## **Proposal for draft amendments to Regulation No. 59**

### **Submitted by the expert from the European Association of Automobile Suppliers**

The text reproduced below was prepared by the expert from the European Association of Automobile Suppliers (CLEPA) to include requirements on silencers or components filled with absorbing materials into Regulation No. 59 (see ECE/TRANS/WP.29/GRB/50, para. 16). The proposed amendments are mainly based on ECE/TRANS/WP.29/GRB/2008/5/Rev.2 and were prepared as a Revision to Regulation No. 59. Modifications to the current text of the Regulation are marked in **bold** characters. Amendments for the insertion of anti-tampering measures are marked in **red colored** characters.

## Test apparatus

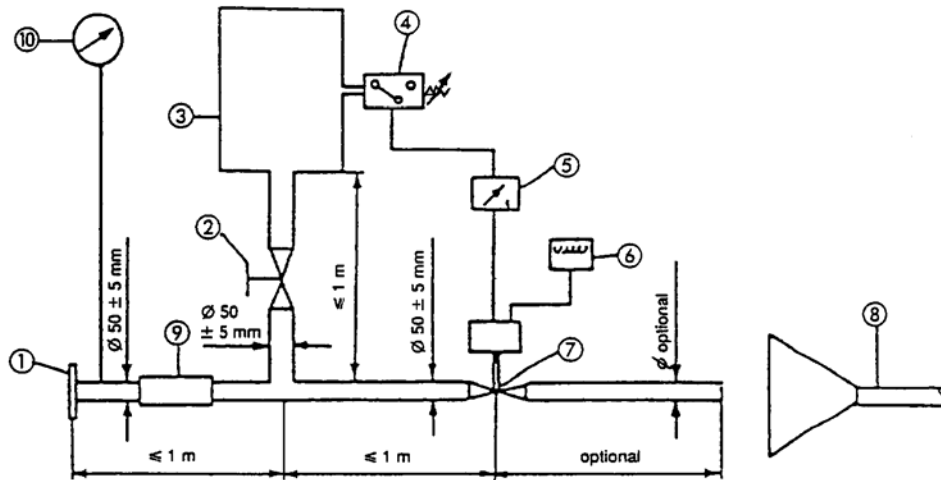
- 1 Inlet flange or sleeve – connection to the rear of complete silencing system to be tested.
- 2 Regulation valve (hand operated).
- 3 Compensating reservoir from 35 to 40 l.
- 4 Pressure switch **5 kPa to 250 kPa** – to open item 7.
- 5 Time delay switch – to close item 7.
- 6 Counter of impulses.
- 7 Quick response valve – such as the valve of an exhaust brake system of 60 mm in diameter, operated by a pneumatic cylinder with an output of 120 N at **400 kPa**. The response time, both when opening and closing, **shall** not exceed 0.5 s.
- 8 Exhaust gas evacuation.
- 9 Flexible pipe.
- 10 Pressure gauge.
